TENNESSEE VALLEY AUTHORITY

April 15, 1982

Enclosed are proposed revisions to chapter 8 of the Watts Bar Nuclear Plant Final Safety Analysis Report (FSAR). This information includes revisions which reflect TVA's compliance at Watts Bar with General Design Criterion 17 and 18. A copy of this information was provided informally to the NRC during a meeting on February 17, 1982.

8.0 ELECTRIC POWER8.1 INTRODUCTION8.1.1 Utility Grid and Interconnections

NUCLEAR SAFETY RELATED  
PEAR FIG. 6.1.2A

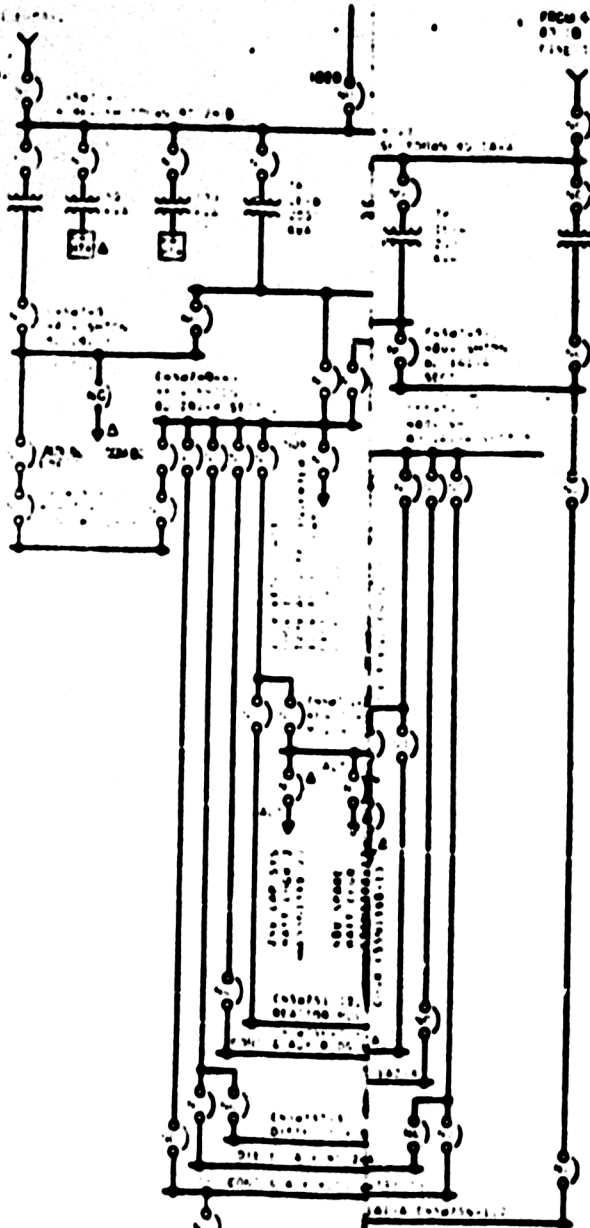
Replace revised Figure 8.1-2 shown in Amendment 44 with the same figure of the previous amendment since the revised figure shows the new fifth diesel generator which has not been formally presented to the NRC. This revised figure will be submitted with the appropriate SAR text at a later date.
